Item ID: D205-596-101 **278** Accept ***N19000040100*** Setup Start ***NS1***
 Revision ID: U/R (14-644) Stop ***NS2***
 Item Name: Fwd Crosstube - Extended Height 39"
 Start Date: 8/18/2015 Start Qty: 1.00 ***1*** Cust Item ID:
 Required Date: 8/21/2015 Req'd Qty: 1.00 ***1*** Customer:
 Reference:

DRAWING NO. D205-596-101	TITLE CROSSTUBE ASS'Y, HI-HI FWD	REV. B	DART AEROSPACE LTD ENGINEERING ORDER		D.E.O. NO. D205-596-101-B-2	SHEET NO. SHEET 1 OF 1	SCALE NTS
DRAWN <i>Q</i>	CHECKED <i>A.P.</i>	MFG. APPR. <i>M</i>	APPROVED <i>MP</i>		DE APPR. <i>MP</i>		
DATE 13.11.11	DATE 13.11.19	DATE 13.11.19	DATE 13/11/21		DATE 13/11/21

DRAWING NO. D205-596-101	TITLE CROSSTUBE	REV. B	DART AEROSPACE LTD ENGINEERING ORDER		D.E.O. NO. D205-596-101-B-3	SHEET NO. SHEET 1 OF 1	SCALE NTS
DRAWN <i>GP</i>	CHECKED <i>A.P.</i>	MFG. APPR. <i>A</i>	APPROVED <i>GP</i>		DE APPR. <i>GP</i>		
DATE 15.01.15	DATE 15.01.20	DATE 15.01.20	DATE 15.01.20		DATE 15.01.20

DART AEROSPACE LTD	Work Order: 135747
Description: Crosstube High-High Fwd	Part Number: D205-596-101
Inspection Dwg: D205-596-101 Rev: B	Page 1 of 1

FIGURE 1 - SUPPORT INSTALLATION

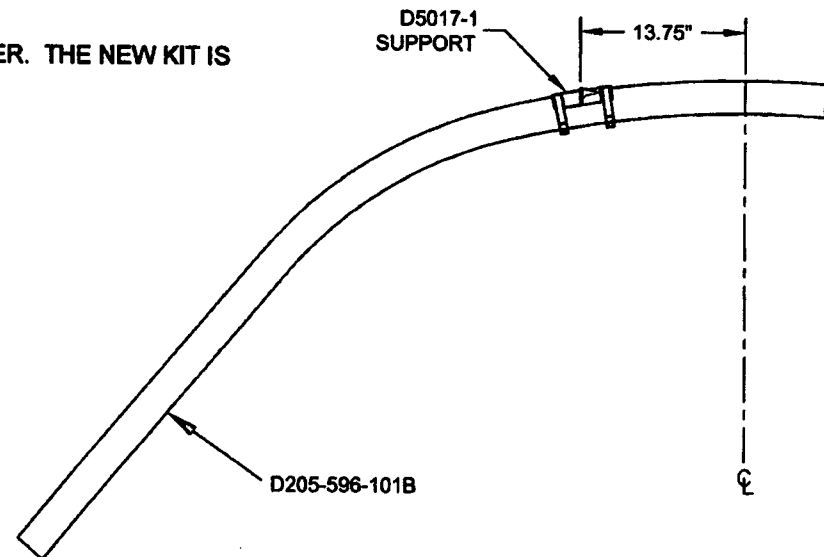
ADD THE FOLLOWING CROSSTUBE ASSEMBLY:

Qty	Part Number	Description
X	D205-596-101B	CROSSTUBE ASSEMBLY (214 HI-HI FWD)

THE D205-596-101B CROSSTUBE HAS THE SAME PARTS LIST AS THE D205-596-101 CROSSTUBE EXCEPT AS FOLLOWS:

INSTALL THE SUPPORTS AS SHOWN IN FIGURE 1 OF THIS ENGINEERING ORDER. THE NEW KIT IS OTHERWISE ASSEMBLED PER THE D205-596-101 CROSSTUBE.

IS:

2	D5017-1	SUPPORT
---	---------	---------

WAS:

2	D2893-1	SUPPORT
---	---------	---------
